SERVICE CAMPAIGN BULLETIN

CAMPAIGN REF: 038
TITLE : McLaren 12C US Emissions Label Correction
DOCUMENT # : 11 P 004
AFFECTED VEHICLES : McLaren 12C Coupe and Spider

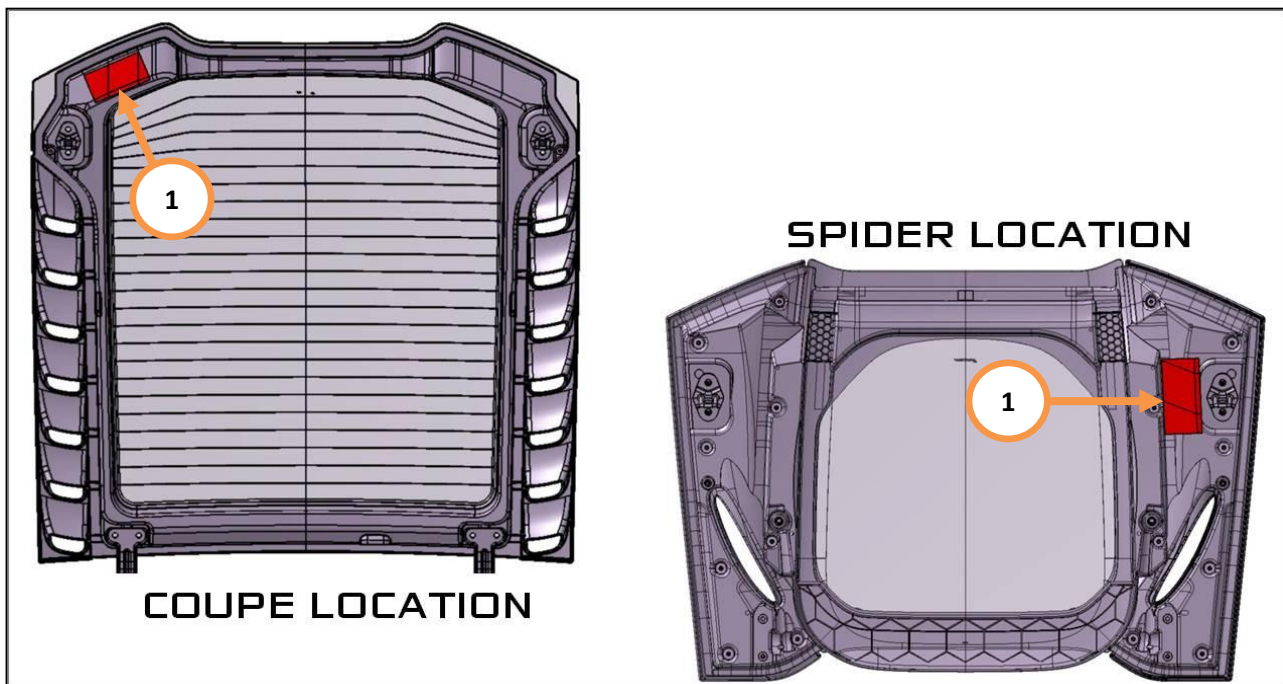
SITUATION : Quality Engineering at McLaren Automotive have identified that a number of vehicles have been fitted with VECI (US Emission) label which has a typing error on them.

1. Open the engine cover.
2. Remove the existing VECI (US Emission) label (1).
3. Clean the surface with an alcohol cleaning solution or similar product to remove any dirt.
4. Install the new label 11P0444CP where the old label was installed.

PROCEDURE : It is necessary to replace the current VECI label with the new label with the correct reference on. Please follow the instructions outlined in this document.
